DWG TITLE: Site Enabling Plan

PROJECT: Thurmoose

4211-460-SEP

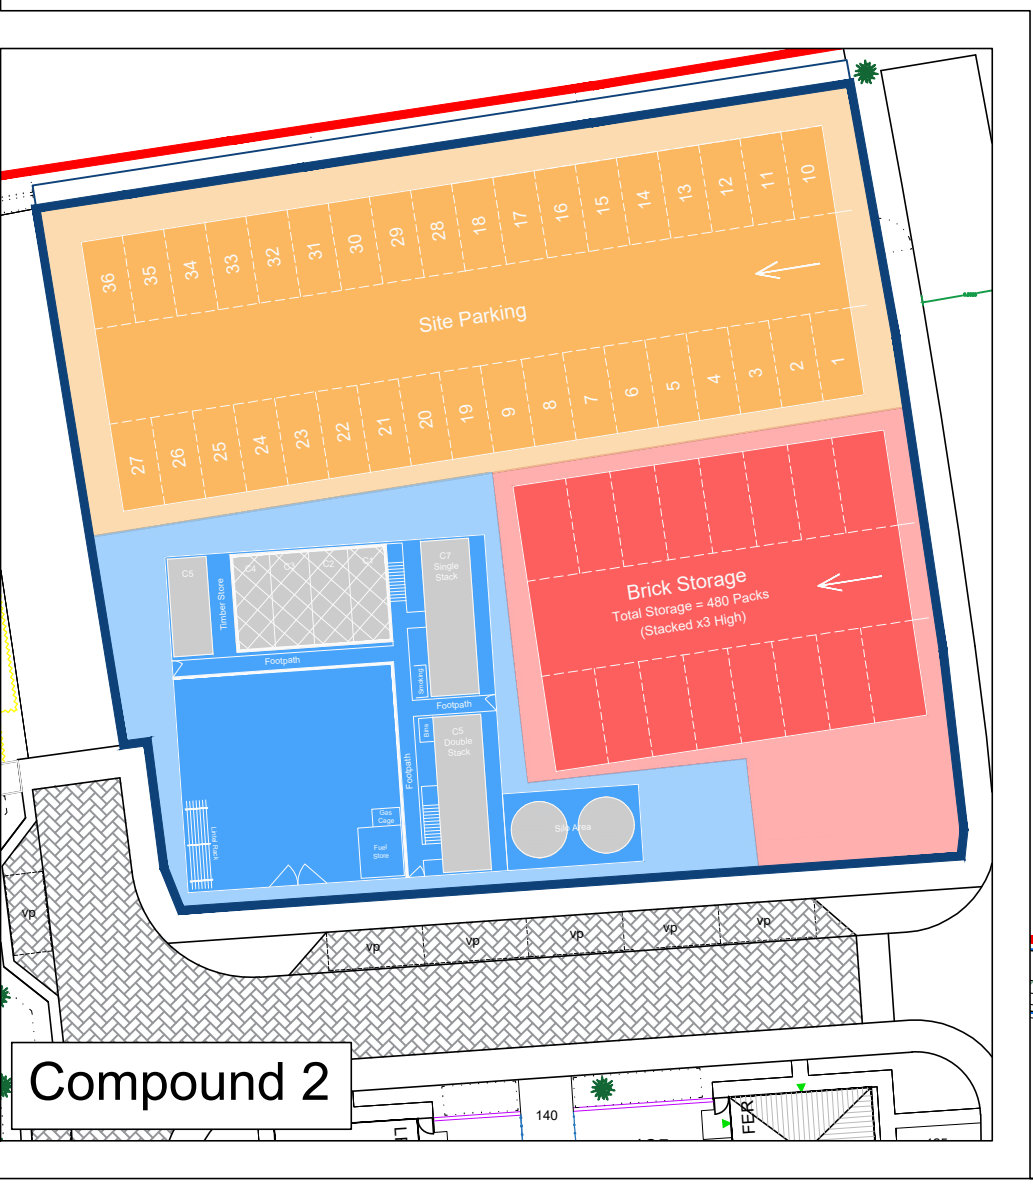
Questions for DM meeting:

- Road phases are large - do they need to be broken down, particularly for the earlier phases?
- Temporary compound location to be confirmed.
- Temporary access in North-East of site required to prior to opening of S278 entrance?
- Compound to be moved due to additionality plots?
